REMARKS

Naoki YUMIYAMA . Serial No.: 09/889,230 Filed: July 13, 2001

ANNOTATED SHEET SHOWING CHANGE

Figs. 2 and 3

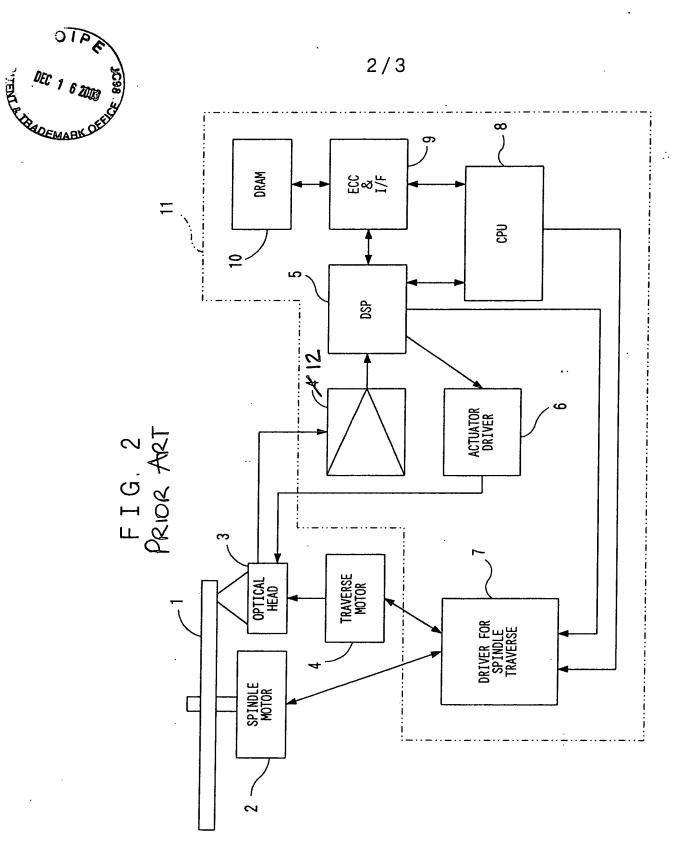
- 1. Objections were stated to the drawings for allegedly not illustrating all of the claim elements and for showing prior art. Submitted herewith is a copy of Figure 2 revised to replace reference numeral 4 (amplifier) with 12. Also submitted herewith are copies of Figures 2 and 3 revised to include a label reading "Prior Art." Withdrawal of the objections to the drawings is respectfully requested.
- 2. Objections were stated to the specification. The specification at page 1, line 23, has been edited to correct a typographical error. The specification also has been amended to remove references to the claims.
